TO: Planning & Zoning Commission
FROM: Heather Valone, Village Planner
THRU: Charity Jones, AICP, Planning & Economic Development Director
SUBJECT: Case 16-05 23 E Logan St
DATE: June 8, 2016

Case No. 16-05
 Project Name 23 E Logan St.

General Information	
Applicant	Ken McClafferty
Status of Applicant	Builder, acting on behalf of the owner.
Requested Actions:	Appeal of the administrative decision to restrict the driveway to alley access.
Site Location	23 E Logan St. (PIN 22-29-105-015-0000)
Existing Zoning	R-4A (Single-Family Preservation & Infill District)
Size	.14 ac
Existing Land Use	Vacant
Surrounding Land Use/Zoning	North: R-4A (Detached single-family residence)
	South: R-4A (Detached single-family residence)
	East: R-4A (Detached single-family residence)
	West: R-4A (Detached single-family residence)
Comprehensive Plan 2030	The Comprehensive Plan classifies this site infill Residential (INF)

TOPOGRAPHICAL SURVEY & SITE DEVELOPMENT PLAN

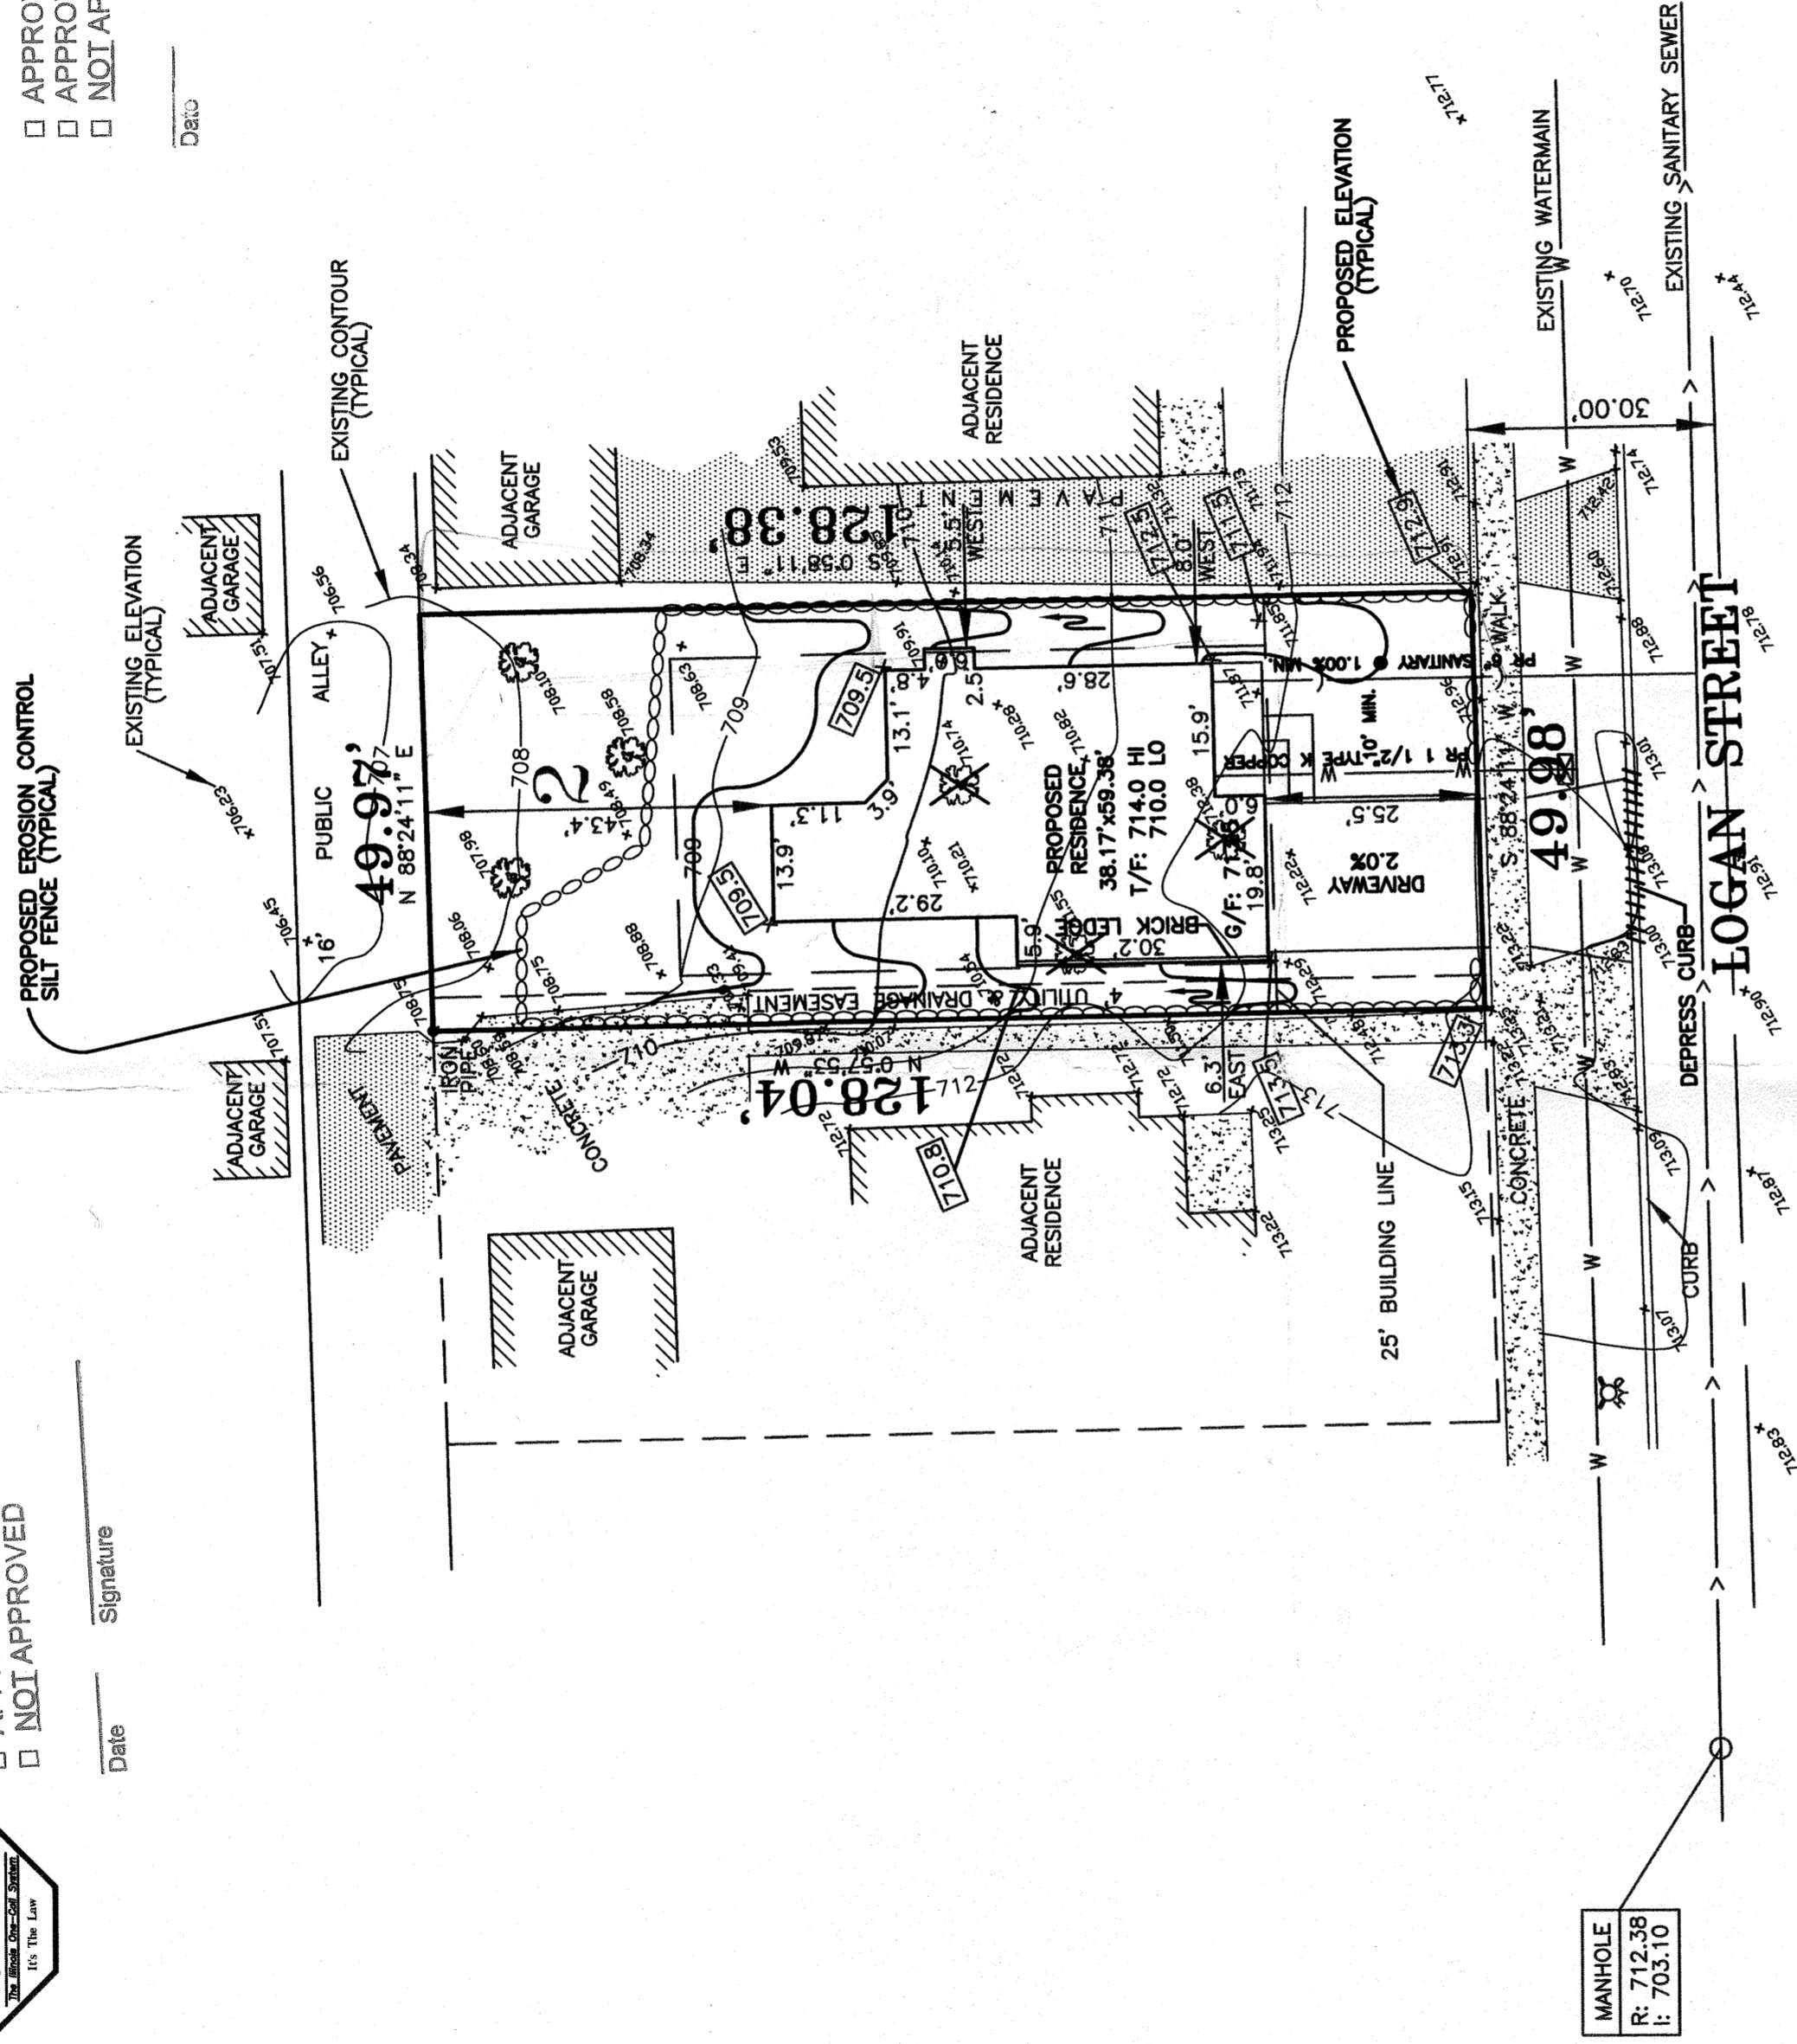
The permit application for 23 E Logan St. was reviewed for alley access from the survey provided by the applicant. The survey indicates that the alley is paved to the property line between 15 and 23 E Logan St. As the subject property was not separated from the paved alley by another property or any distance, staff found that the alley does provide access to the subject property. Though the alley is not paved across the entire rear lot line of the property, the alley is only required to be extended along the subject property, not across other private properties.
